REDWOOD LANDFILL SOLID WASTE FACILITIES PERMIT REVISION

*Final Supplemental
Environmental Impact Report*

*Volume II: Response to Comments
and Appendices*

COMMENTS AND RESPONSES

REDWOOD LANDFILL PROFILE
PROPOSED COUNTOURS ON TOP OF PERMITTED COUNTOURS
DIAGRAM A
DWN 8/8/03

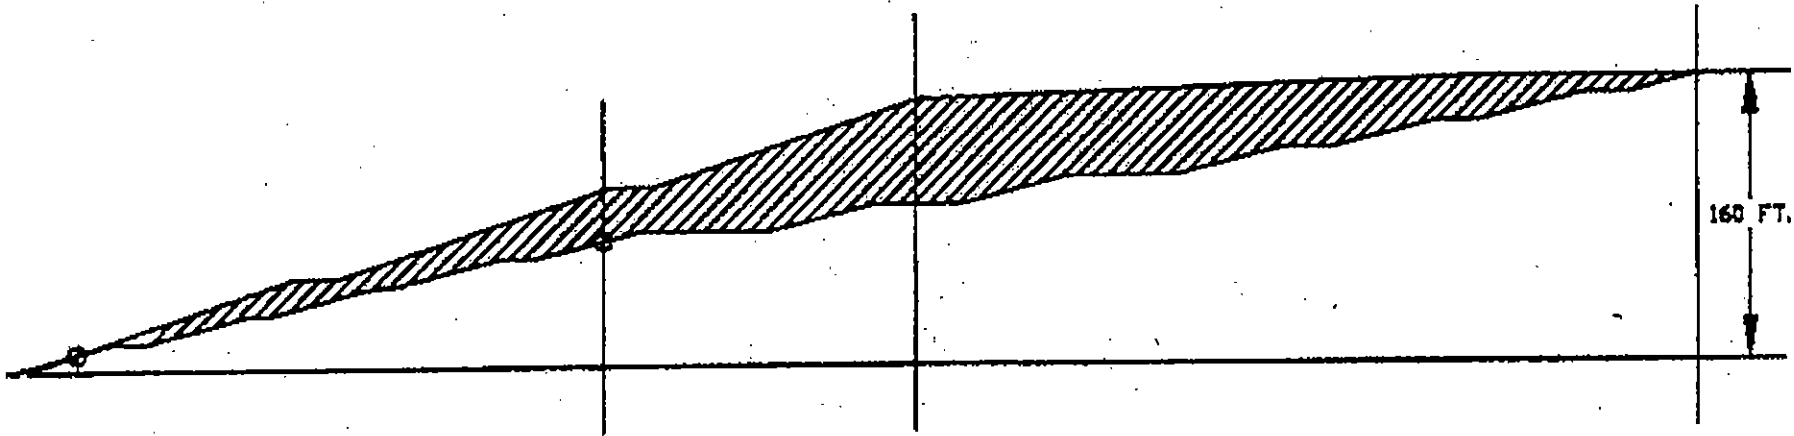
The Proposed Project advocates doubling the capacity of the landfill by making the sides of the fill steeper and by filling in areas that are currently being used for ponding. The increase in slope, 3:1 from 4:1, and reducing the number of benches, changes the profile of the landfill sides substantially. Figure 2-4, Page 2-14 does not adequately allow the reader to appreciate the major change proposed. By taking a section "A" – "A" through the length of the landfill, the side slopes in Figure 2-4 are difficult to discern. We have reconstructed a comparison slope diagram, Diagram A attached, using the elevation lines shown in Figures 2-5 and 2-6, to show the sideslopes in the vicinity of the west side of Area G. The diagram illustrates the significant additional waste material at the top of the side slope, applying pressure on this side slope.

- CCC-1. Please refer to Master Response 12
- CCC-2. The final height of the landfill would not change as a result of the project. The project element pertaining to landfill slopes consists of the proposed increase in the steepness of the slopes from 4:1 to 3:1, a decrease in the width of the slope benches, and an increase the intervals between benches. If approved, these changes to the landfill's geometry would be implemented as the successive refuse layers and cover are placed, to the landfill's permitted elevation of 166 feet above sea level. Please refer to DSEIR Figures 2-4, 2-5, and 2-6 in Chapter 2, Project Description. .
